**49 CFR Part 572**

[Docket No. NHTSA-2000-7051]

**Anthropomorphic Test Devices; 3-Year-Old Child Crash Test Dummy**

**ACTION:** Final rule.

**Figure P3**  
**NECK EXTENSION TEST SET-UP SPECIFICATIONS**

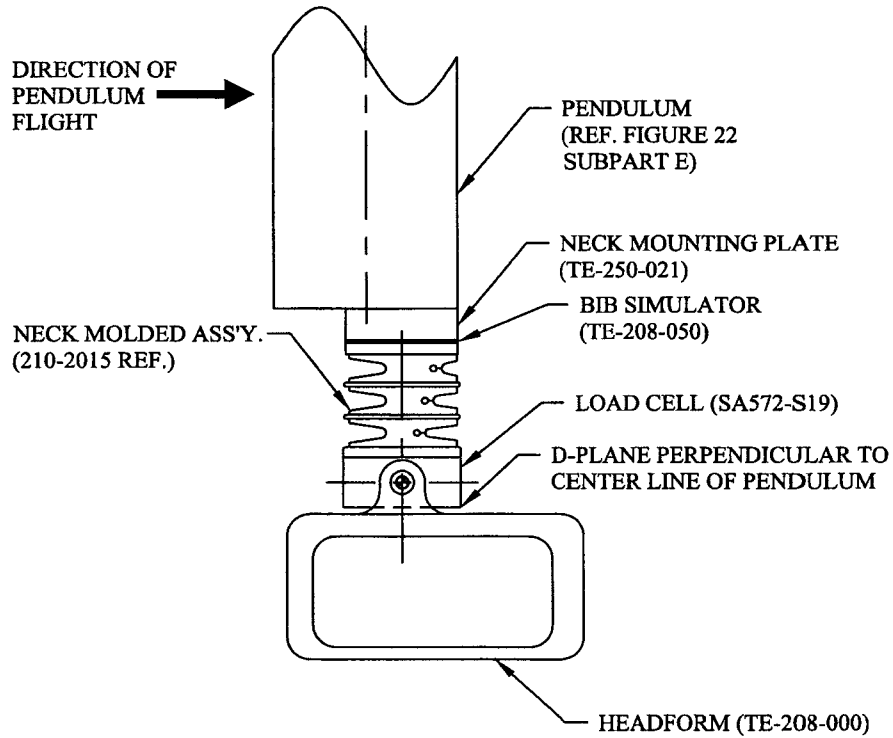
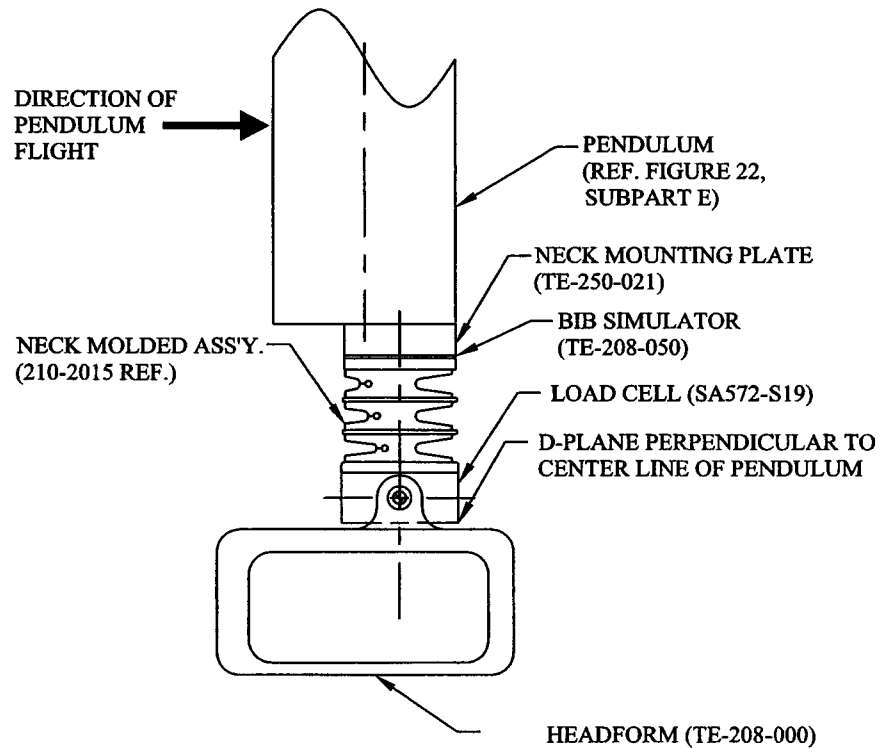
GM notes that SAE compiled data suggest a need to shift the peak rotation corridor in extension from 80–90 degrees to 83–93 degrees. This suggested revision does not increase the width of the corridor proposed in the NPRM, but raises the mean value from 85 degrees to 88 degrees. Also, GM believes that the data indicate a need to widen the peak negative extension moment corridor from the range of –42 N-m to –53 N-m to a range of –41 N-m to –56 N-m as a reflection of a slightly larger spread of the SAE data base. The revised peak moment corridor has nearly the same average (–48 N-m), but is 4% larger in spread than that proposed in the NPRM (15.5% vs. 11.5%). GM agrees with the rest of the neck extension performance corridor requirements and pendulum pulse specifications in NPRM.

We have examined all of the available extension calibration data. The data indicate that the mean peak rotation is 88 degrees with a s.d. at  $\pm 2.2$  degrees. Accordingly, we agree with GM that the peak rotation corridor should be adjusted to the recommended 83–93 degrees range. As for peak negative moment, we agree with GM's recommended mean value of –48.5 N-m but do not agree with the recommended corridor range of  $\pm 15.5\%$ . The available data yields a s.d. of 3.7 which corresponds to the  $\pm 15\%$  response corridor at 2 s.d. As explained above in the discussion of neck flexion requirements, the desirable dispersion range for consistency in repeatability should be below 8%, but should not exceed 10%. Applying the 10% limit value yields a peak force response

corridor between –43.7 N-m and –53.3 N-m. The revised range is particularly important to assure that the variability of the critical extension moment is not the cause of contention in vehicle compliance tests. As noted in the above discussion, improvements in quality control of necks in production would achieve the desired repeatability in response.

(i) Plane D referenced in Figure P3 of this subpart shall rotate in the direction of preimpact flight with respect to the pendulum's longitudinal centerline between 83 degrees and 93 degrees. Within this specified rotation corridor, the peak moment about the occipital condyle may be not more than -43.7 N-m and not less than -53.3 N-m.

Figure P4  
**THORAX IMPACT TEST SET-UP SPECIFICATIONS**

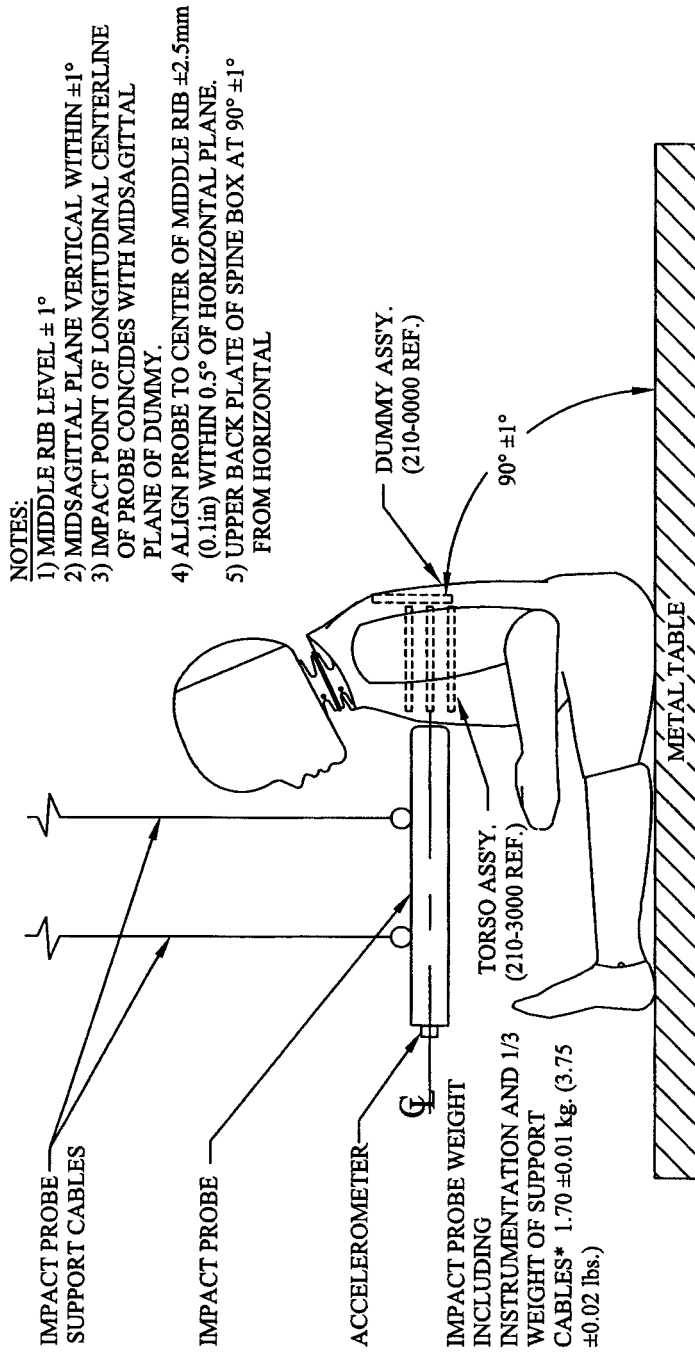
Mitsubishi is concerned about the NPRM's lack of dimensional tolerance for the 50.8 mm diameter of the thorax impact test probe. The commenter recommends the probe diameter at  $50.8 \pm 0.25$  mm. We have added the suggested dimensional tolerance along with other modifications involving the development of generic specifications for all impactors.

GM indicates agreement with most of the thorax performance requirements and probe specifications in the NPRM, with the exception of the peak force corridor. GM suggests, based on SAE data, that the corridor should be shifted upward from the proposed range of 600–800 N to 650–850 N. GM's suggested corridor is based on an average of 750 N, and therefore its percentage is slightly lower in width (by approximately 1% (13% vs. 14%)).

We examined all of the thorax impact data available to us, which includes the SAE data supplied in docket comments and our data generated at VRTC. The combined data sets yield an average impact response of 746 N with s.d. of 32 N, indicating that the NPRM corridor needs adjustment in both the mean response value and the corridor's width. The data suggest that the response corridor's width can be set at  $\pm 2$  s.d. while remaining just above the 8% good to marginal acceptability norm. Accordingly, this final rule adjusts the thorax response corridor to a new range between 680 N minimum and 810 N maximum, which is within but slightly narrower than the response range recommended by GM.

We have analyzed the H-III3C dummy's thorax response and found that statistically the peak force of a well-functioning dummy in the transition compression zone could be as high as 860 N. Accordingly, we are including in § 572.144 (b)(1) a 860 N peak force limit for a compression zone bounded between 12.5 mm and 32 mm.

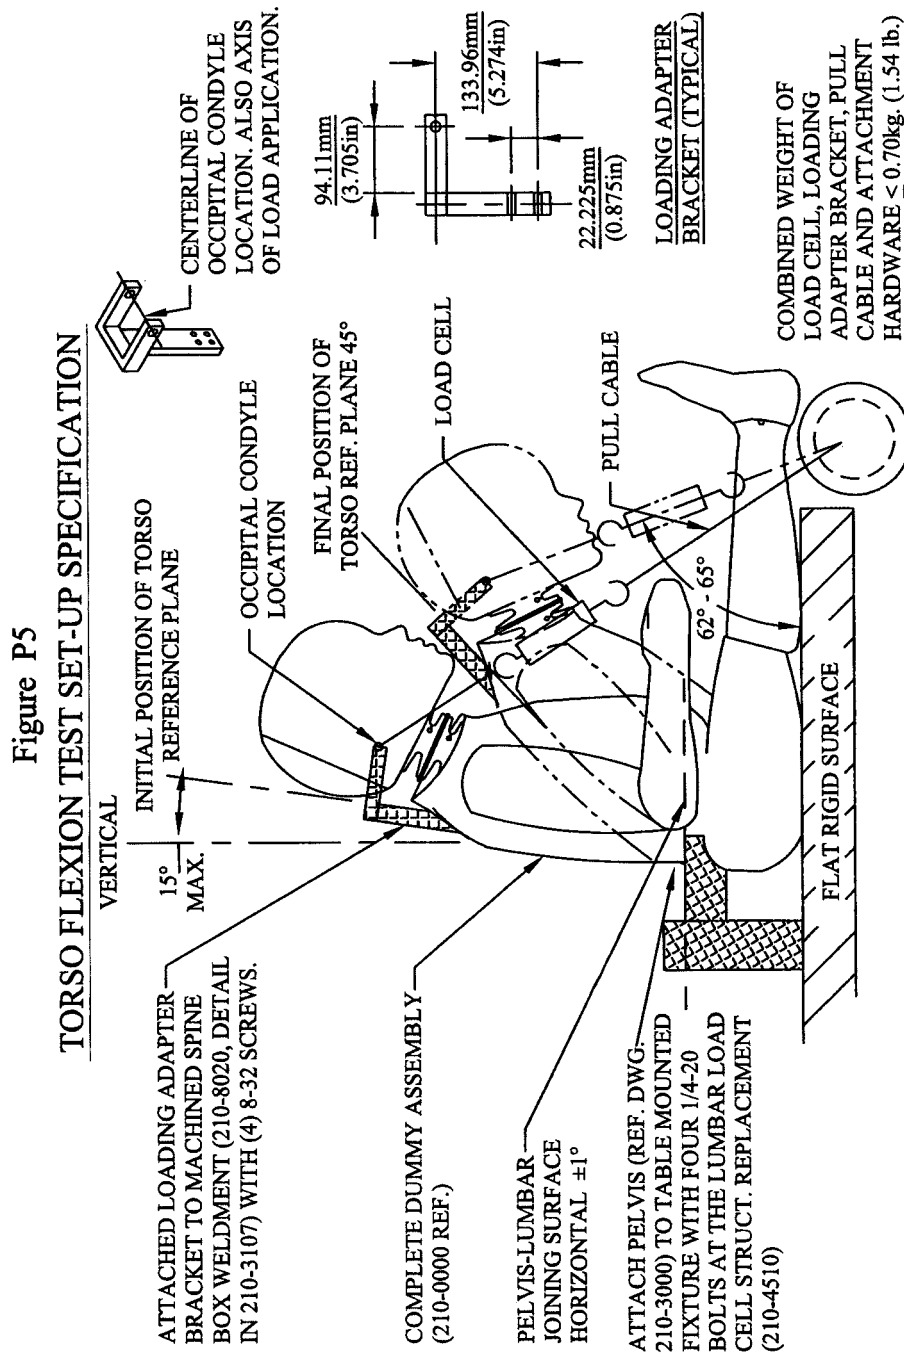
Mitsubishi believes the 0.75 kg mass for the loading adapter bracket that holds the torso is proportionally too large considering the dummy's relatively small mass and its soft spine with respect to the larger size Hybrid III

We have clarified section S572.145(c), which specifies the installation of the loading bracket, its design, the attachment of the pulling mechanism and the sequence of applying and releasing of the pull forces. Figure P5 contains considerable additional detail regarding the loading bracket, its installation on the dummy, and alignment of the point of load application with respect to the occipital condyle.

We agree with Mitsubishi that the mass of the loading bracket should be reduced. In light of the comment, we have reviewed the masses involved in the system that flexes the dummy. As a result of this review, we are revising the specification of mass associated with the pull test to a maximum of 0.70 kg. This mass includes all of the dummy-based attachments and hardware,  $\frac{1}{3}$  of the pulling wire, and the load cell that is used to measure the pull load. Inasmuch as the same load cell is being used for tests of other size dummies, there is little flexibility to reduce its weight short of designing a new one, which would unnecessarily delay this rulemaking. Because we are specifying a maximum weight for the entire system, test facilities will have some flexibility in selecting the weight of individual components of the system, such as the loading adaptor bracket. Thus, a weight tolerance for the loading adaptor bracket is not needed.
